File 1988-0010

Project Name: Multi-Theater – Special Use Permit - 590 24 ½ Rd.

PROJECT NARRATIVE
SPECIAL USE PERMIT
FOR
MULTI-THEATRE IN A C-2 ZONE

SITE PLAN

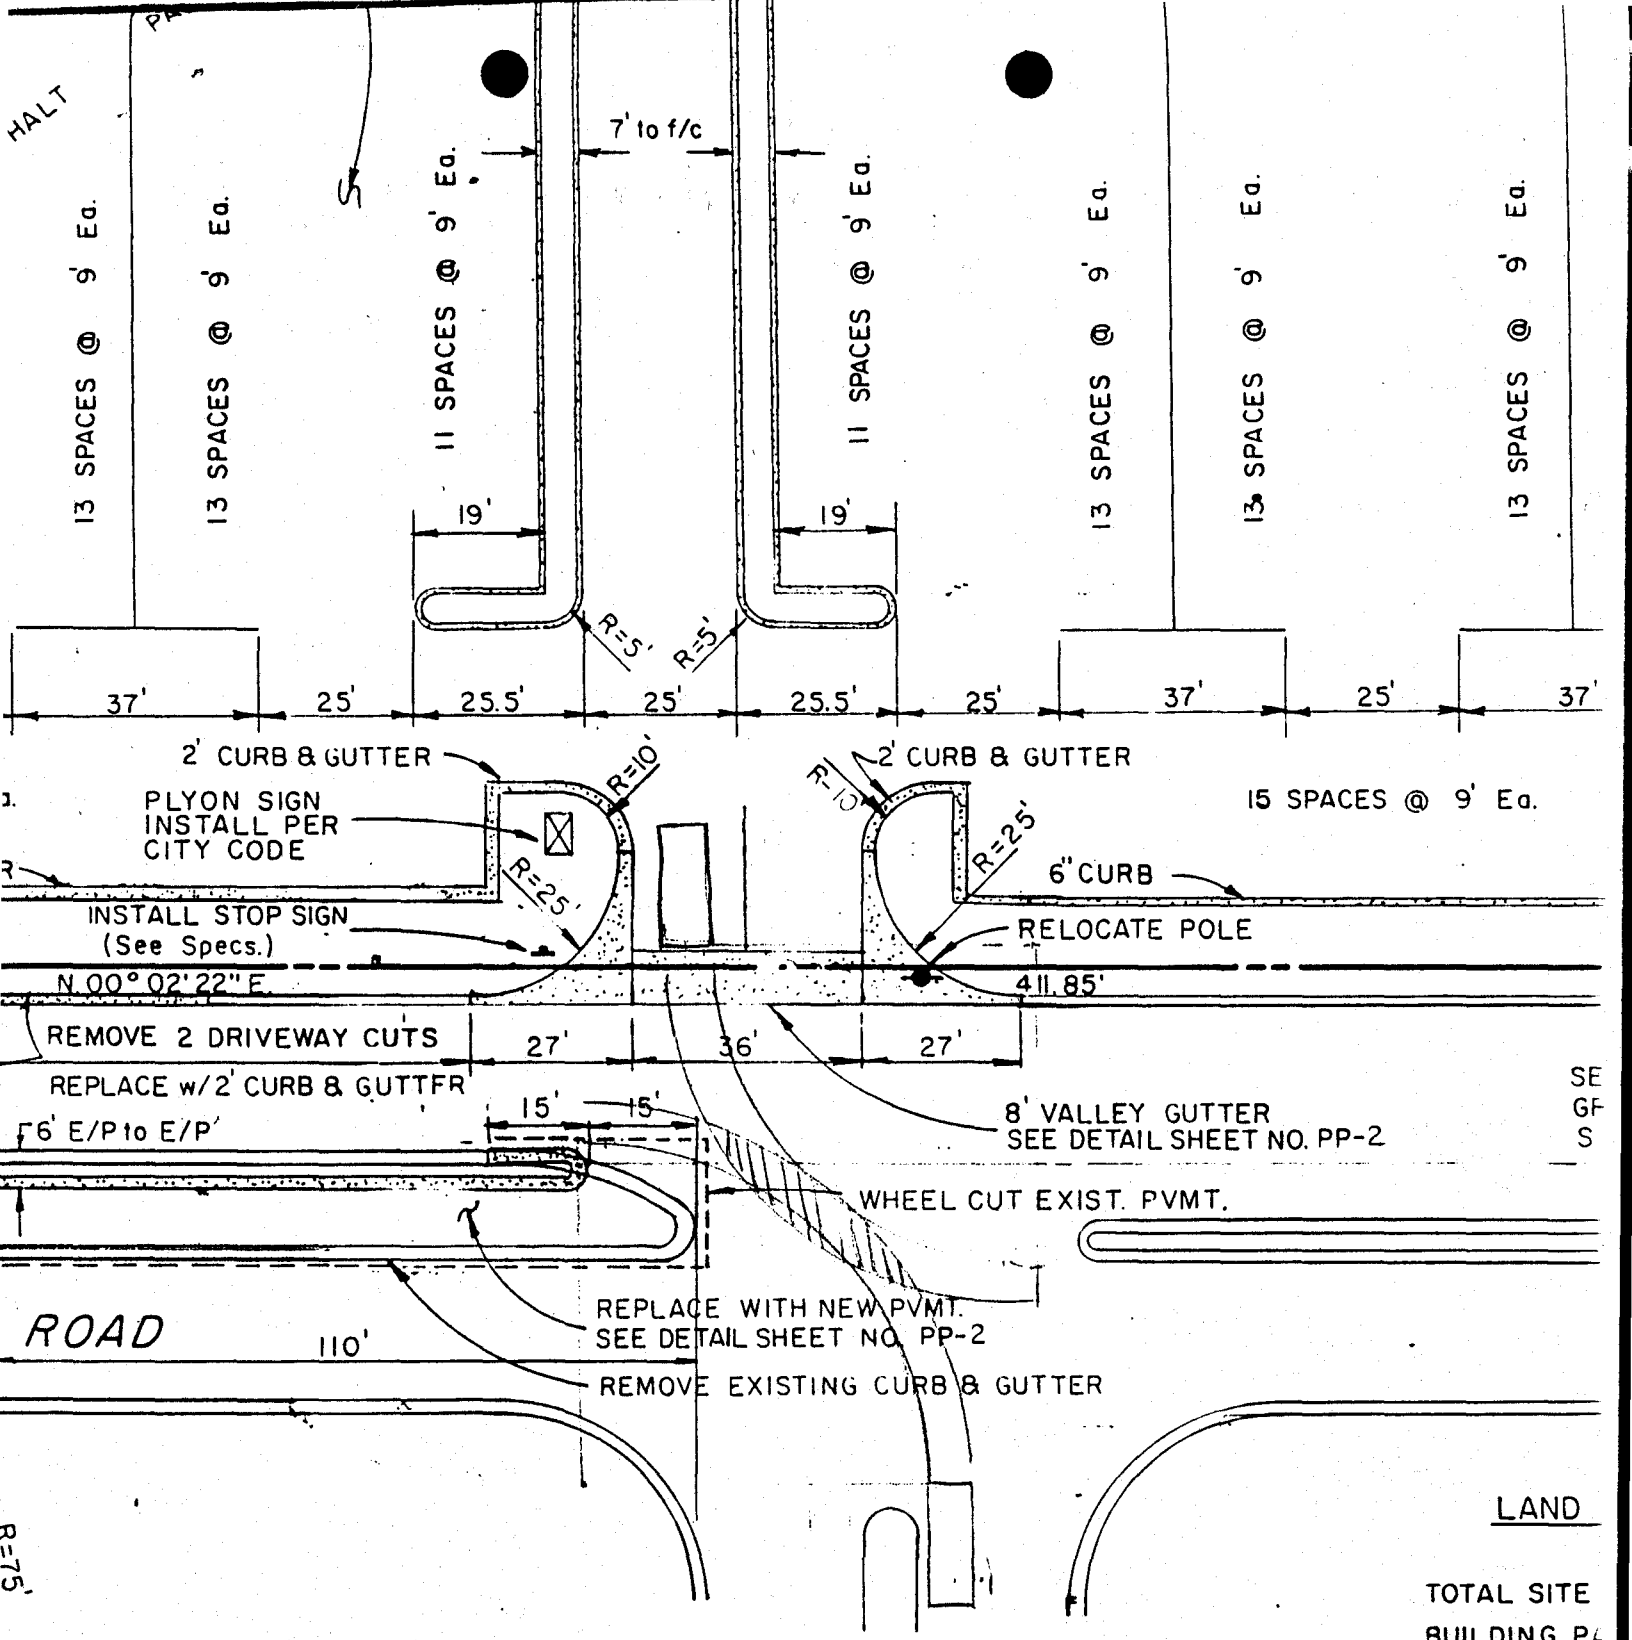
Note: No curb cut
Permit without
left turn lane

ALTERNATE BID ITEM
Cut existing median
back 20'

this driveway should be widened from 27' to 36' to accommodate a right turn lane out!
